ORIGINATION FORM

Proposed Revisions to a Standard Plans Index
(Please provide all information — Incomplete forms will be returned)

Index Number: 521-428

Index Title: Concrete Barrier/Noise Wall - Junction Slab

PLAN
JUNCTION SLAB ADJACENT TO SKEWED APPROACH SLAB AND WITH BARRIER WALL INLET

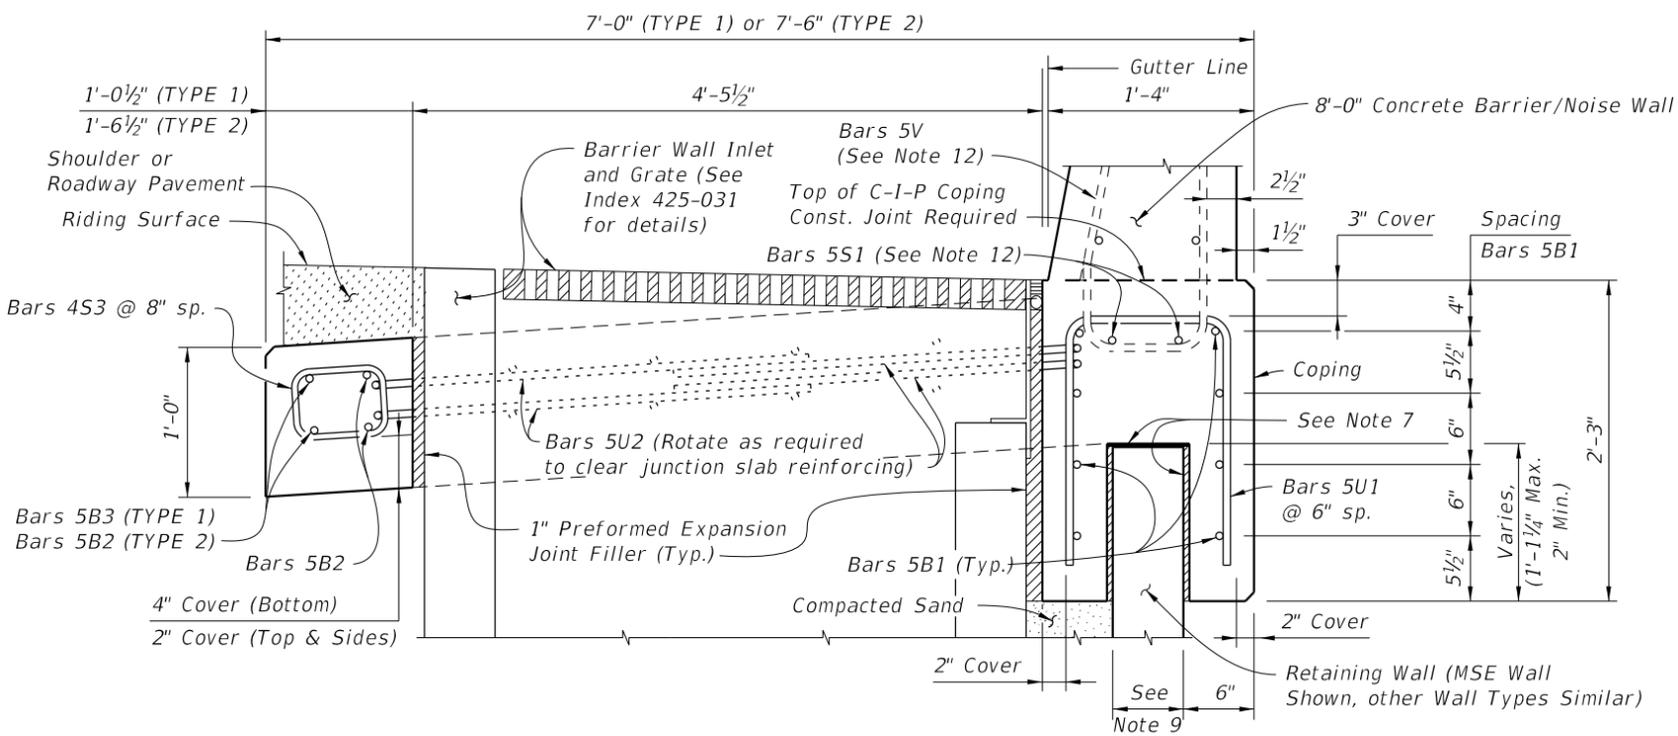
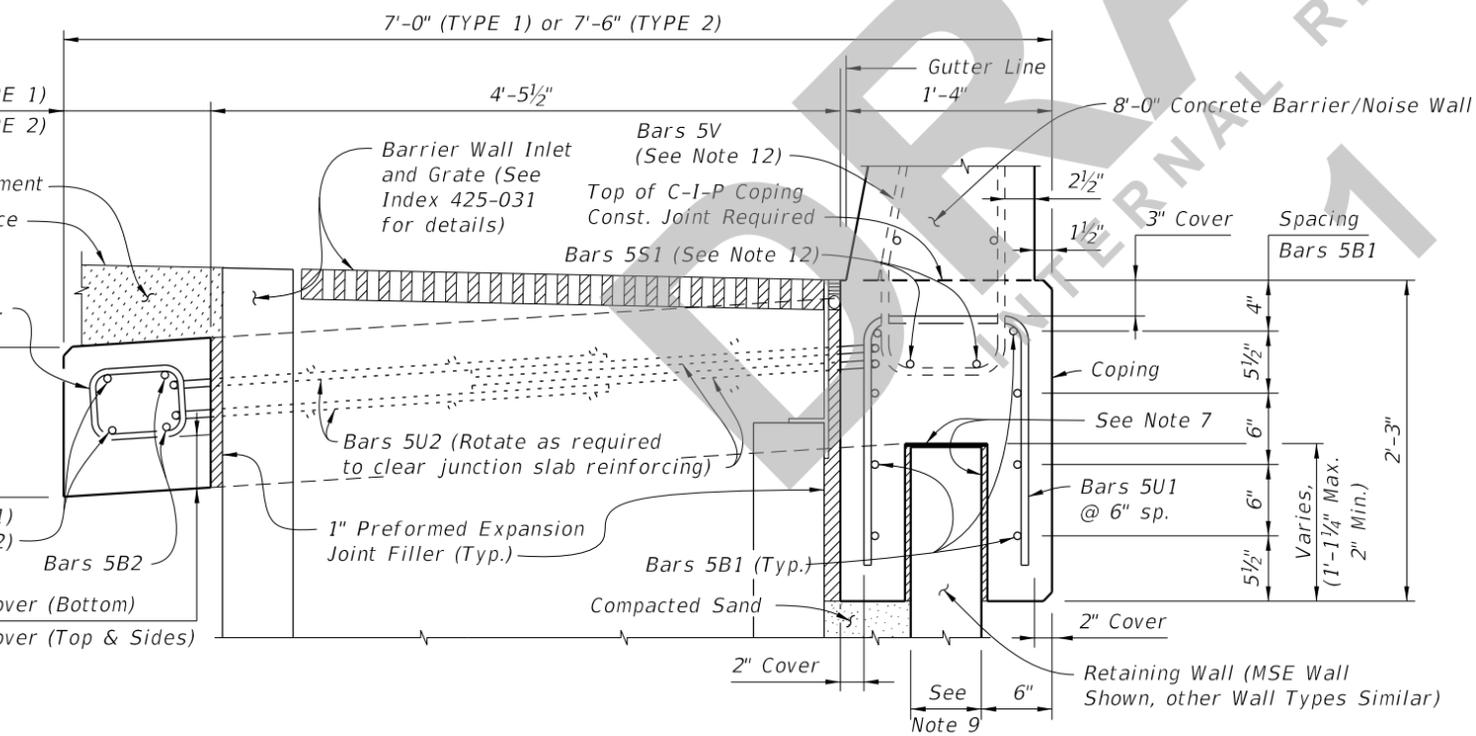
changed title; Sheet 2: Added Notes 8 & 9; changed Note 6

Title - removed 8'. Note 6 changes from Pavement; Notes 8 & 9 additional information (D-6)

7. Provide Organic Felt bond breaker on top and Expanded Polystyrene (1/2" thick) on sides of retaining wall.
8. Shoulder or Roadway Pavement is required on top of the junction slab for its entire length on the traffic side of the Barrier/Noise Wall. See Section B-B for details.
